## TECHNICAL BULLETIN

**407-07-78**

**MODEL AFFECTED:** 407

**SUBJECT:** AFT FUSELAGE BULKHEAD AT FS 231.4,  
INSTALLATION OF.

**Figure 1 - Installation of Aft Fuselage Bulkhead (sheet 1 of 4)**

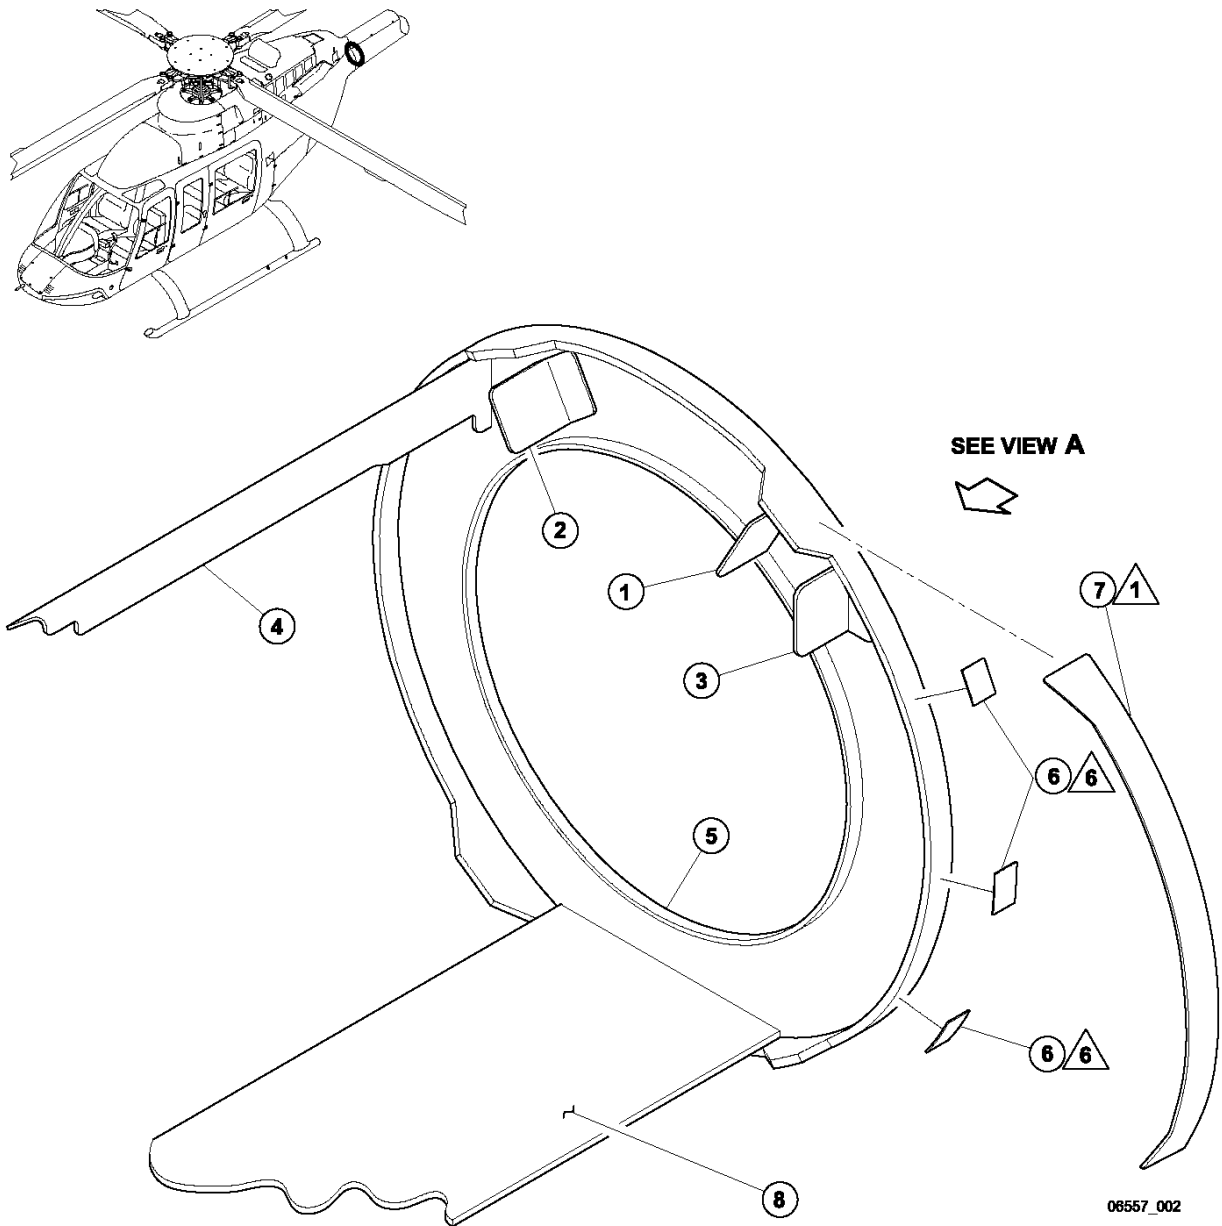
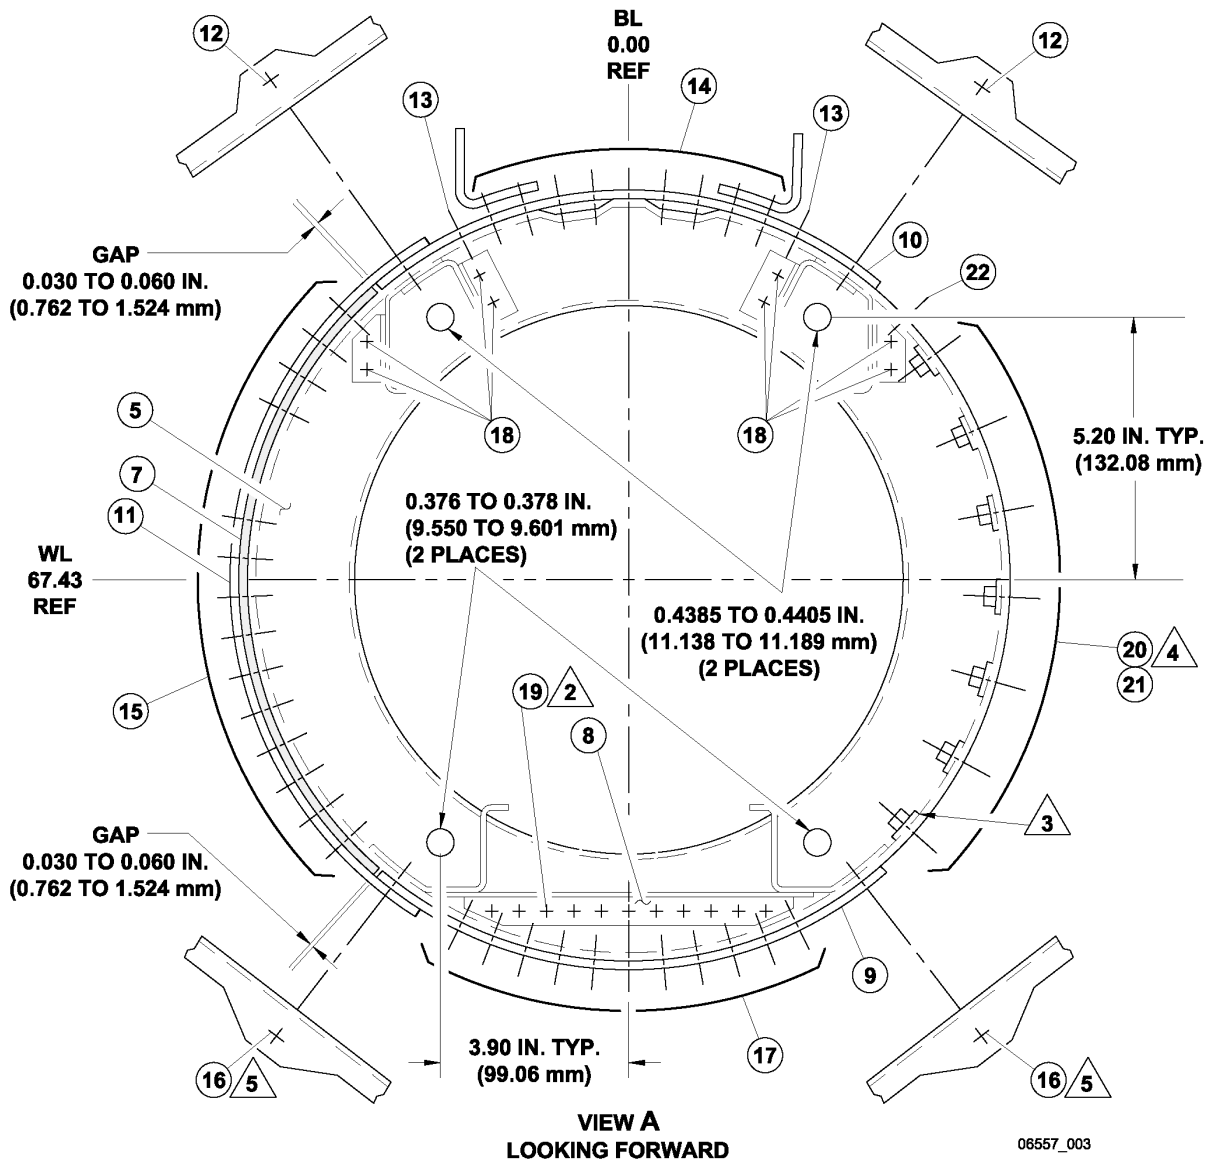
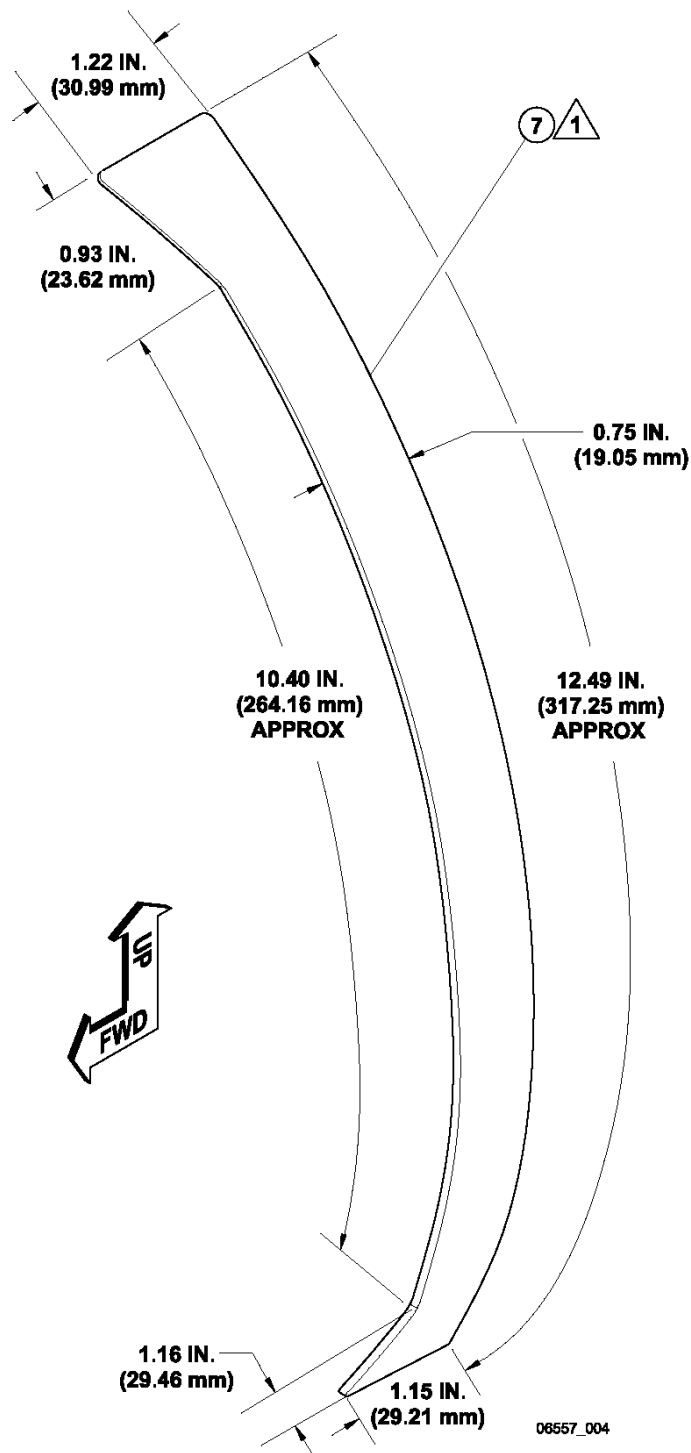
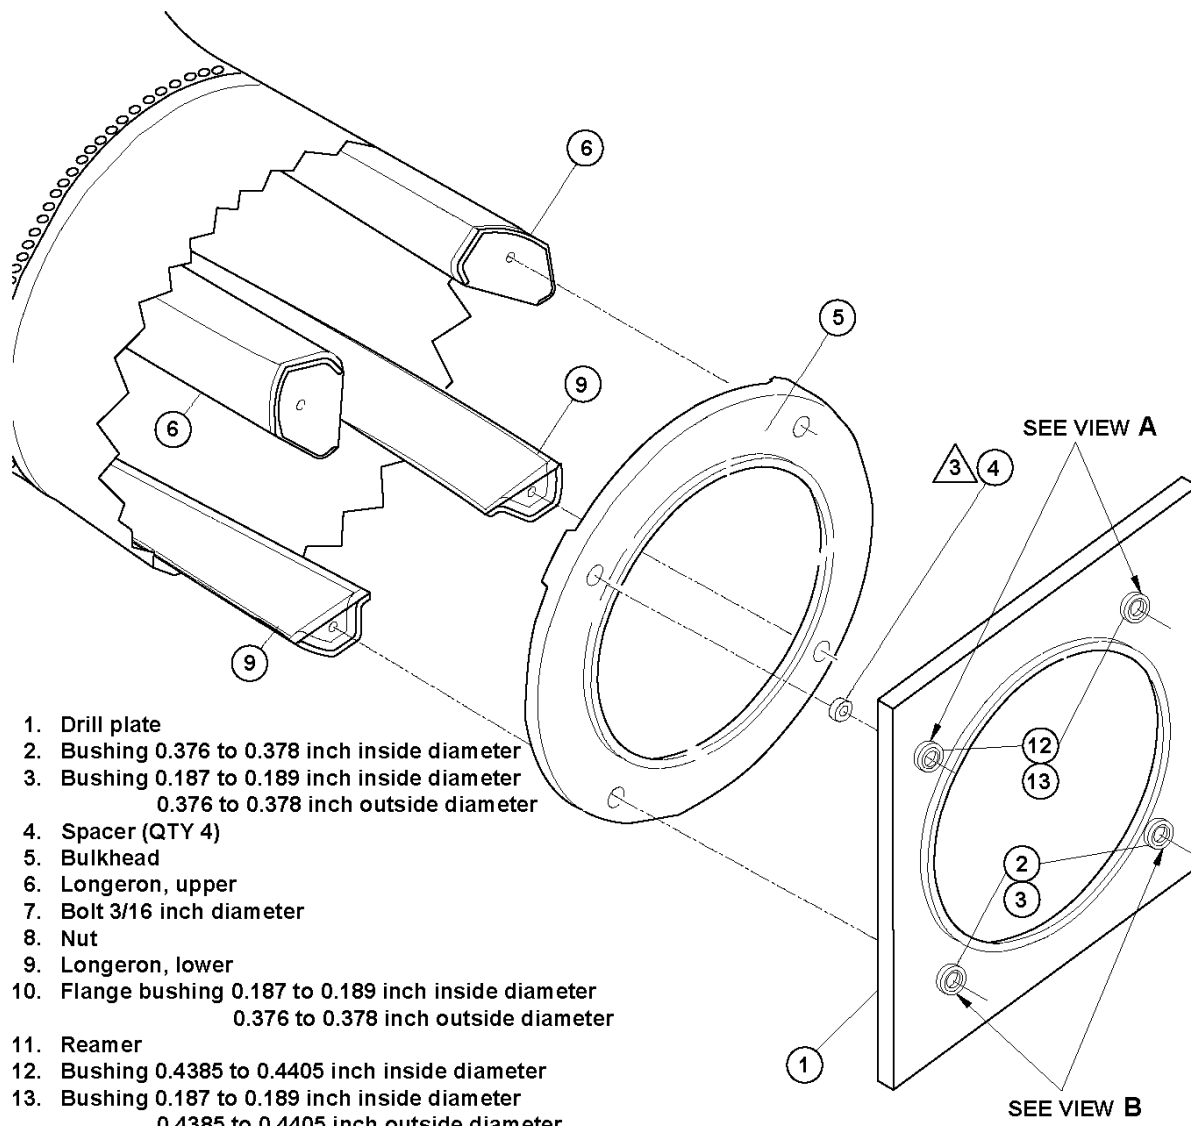
Simultaneously to the publication of the Technical Bulletin 407-17-125, **Revision A** of this bulletin 407-07-78 includes the installation procedures of a new machined aft fuselage bulkhead 407-030-027-107, which has a reinforced (thicker) inside flange in the upper left area and is a spare replacement on all 407 model helicopters. 407 serial numbers 53989, 54807, 54808, 54869 through 54871, and 54877 and subsequent were/are delivered with the 407-030-027-107 bulkhead installed. **Revision B** of this bulletin 407-07-78 incorporates clarifications and modifications to the accomplishment instructions steps where the in-plane condition of the aft fuselage longerons is verified.

Due to the left upper inside flange of bulkhead 407-030-027-107 being thicker, interference with original longeron may occur. As required, trim minimum material from longeron to clear aft bulkhead 407-030-027-107 added thickness of lower flange while ensuring 0.030 inch (0.762 mm) minimum gap is maintained between parts.

Due to the left upper inside flange of bulkhead 407-030-027-107 being thicker, interference with original longeron may occur. As required, trim minimum material from longeron to clear aft bulkhead 407-030-027-107 added thickness of lower flange while ensuring 0.030 inch (0.762 mm) minimum gap is maintained between parts.

17. Secure bulkhead (5) to longeron fittings with drill plate as shown (View D).
18. Secure aft bulkhead (5) with rivets (14, 15, and 17) as shown in (Figure 1, View A).

21. Secure bulkhead (5) to longeron fitting with drill plate as shown (View D).
22. Secure aft bulkhead (5) with rivets as shown in (Figure 1, View A).
23. Remove drill plate from aft fuselage.

**Figure 2 - Installation of Drill Plate (sheet 1 of 2)**

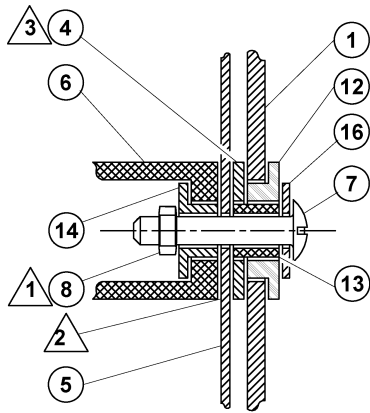
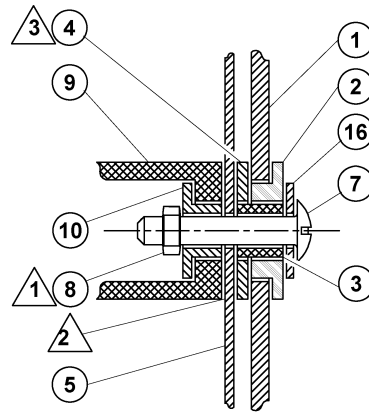
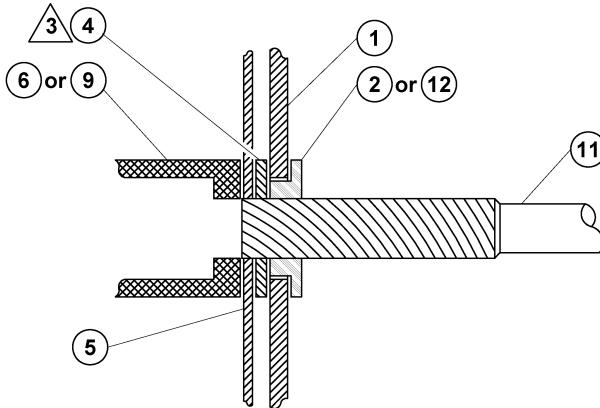
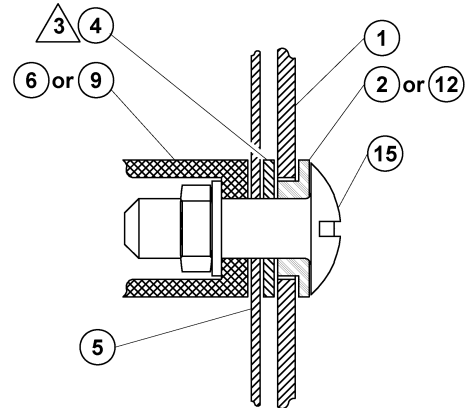
1. Install new aft bulkhead (5, Figure 2) into position. Attach drill plate (1) using bushings (12, 13, and 14) to aft fuselage at upper left and right fittings (6) (View A). Attach drill plate (1) using bushings (2, 3, and 10) at lower left and right fittings (9) (View B). Install bolts (7) and nuts (8), torque the nuts (8) to 50 inch-pounds (5.65 N-m) .
2. Measure gap between left aft skin (11, Figure 1) and bulkhead (5). Record value.
3. Fabricate shim (7) from 2024T3 or 6013T4 aluminum material to dimension shown (Figure 1) and thickness to the value recorded in step 2. Maximum shim thickness not to exceed 0.080 inch (2.032 mm). Taper as required to a minimum of 0.005 inch (0.127 mm).
4. Position shim on left of bulkhead and trim as required to obtain a gap of 0.030 to 0.060 inch (0.762 to 1.524 mm) to at each extremity.

6. Install flange bushing (10, Figure 2) in both lower longeron/fitting (Figure 2, View B). Backdrill 0.187 to 0.189 inch (4.75 to 4.80 mm) from longeron into the bulkhead (5). These holes are the new pilot holes.

10. Drill both upper longeron/fitting holes by increasing size of drill bit until final ream of bulkhead (5) to 0.4385 to 0.4405 inch (11.1379 to 11.1887 mm) can be achieved.
11. Separate bulkhead from drill plate. Deburr holes and clean with acetone (C-316). Apply chemical film (C-100) and primer (C-204) to all bare metal surfaces (BHT-ALL-SPM, Chapters 3 and 4).
12. Position bulkhead on aft fuselage. Install drill plate with full size nut, bolt and washer (15) (Figure 2, View D). Torque nuts to 50 inch-pounds (5.65 N-m).

**Figure 3 - Fabrication of Aft Fuselage/Tailboom Attachment Drill Plate**

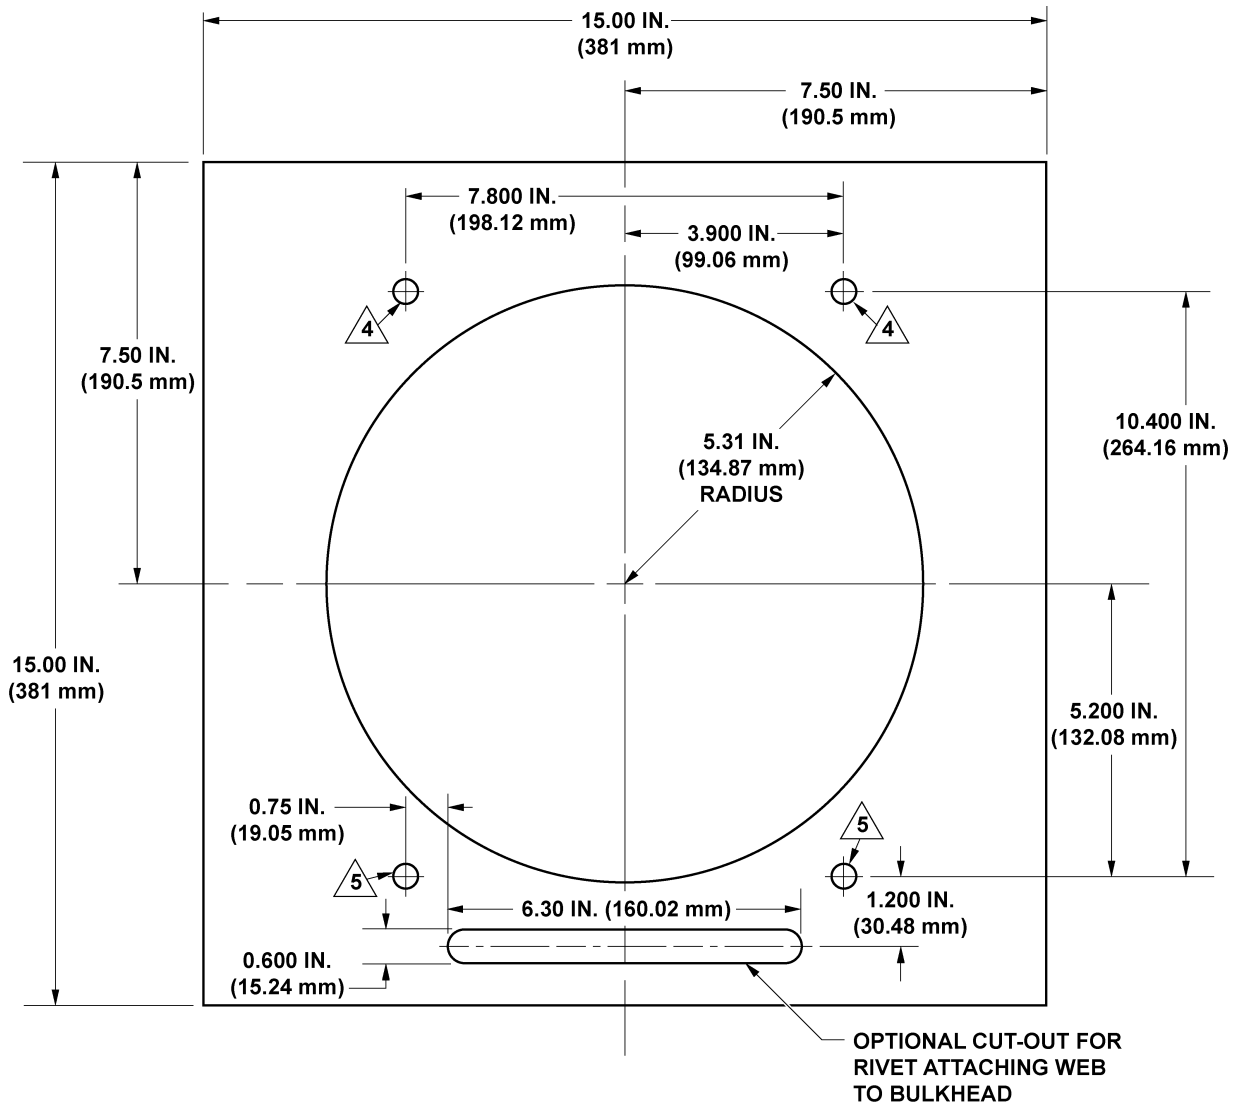
- h) Separate bulkhead (5) from aft fuselage structure using a warm thin blade putty knife to release sealant. Remove and discard bulkhead (5) with shims (6).
2. If required, locally manufacture a drill plate to dimension shown (Figure 3).
  3. If an existing tailboom attachment drill plate is to be used, confirm the condition of the tailboom attachment drill plate prior to next step.
    - a) Verify that the flatness requirement is respected (Figure 3).
    - b) Verify that the dimensional and positional requirements of the tailboom attachment holes (qty 4) are respected (Figure 3).
